**To: T10 SAS Protocol Working Group**

**From: Brian Day (LSI)**

**Subject: SAS 2: Only issue BROADCAST(CHANGE) for initial Spinup Hold**

Revision 0 - Initial draft (September 12, 2007)

Figure 1 — SP (phy layer) state machine - SATA spinup hold state

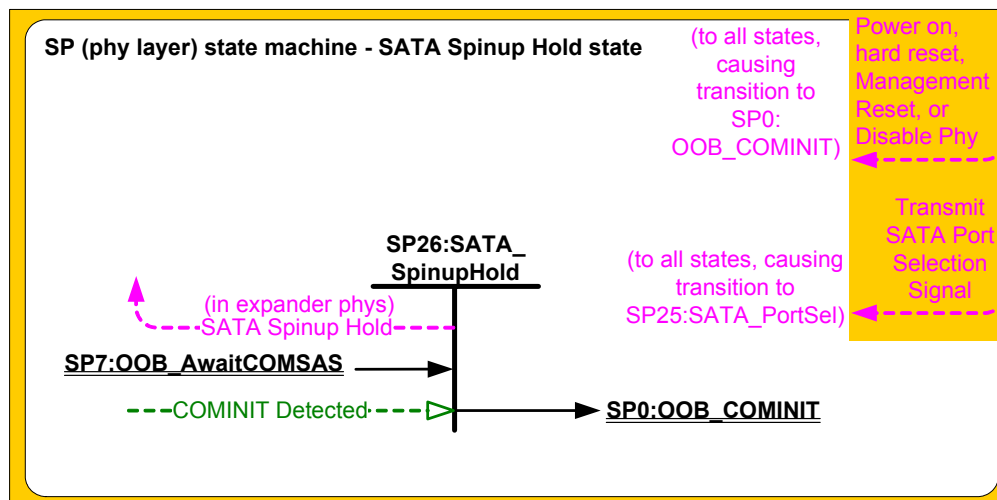
~~Upon entry into this state, this state shall set the ResetStatus state machine variable to SPINUP\_HOLD.~~

~~If this state machine is in an expander phy, this state shall send a SATA Spinup Hold confirmation to the link layer.~~

Upon entry into this state, this state shall:

- a) if the ResetStatus state machine variable is set to SPINUP\_HOLD, not change the ResetStatus state machine variable; or
- b) if the ResetStatus state machine variable is not set to SPINUP\_HOLD:
  - A) set the ResetStatus state machine variable to SPINUP\_HOLD; and
  - B) if this state machine is in an expander phy, send a SATA Spinup Hold confirmation to the link layer.
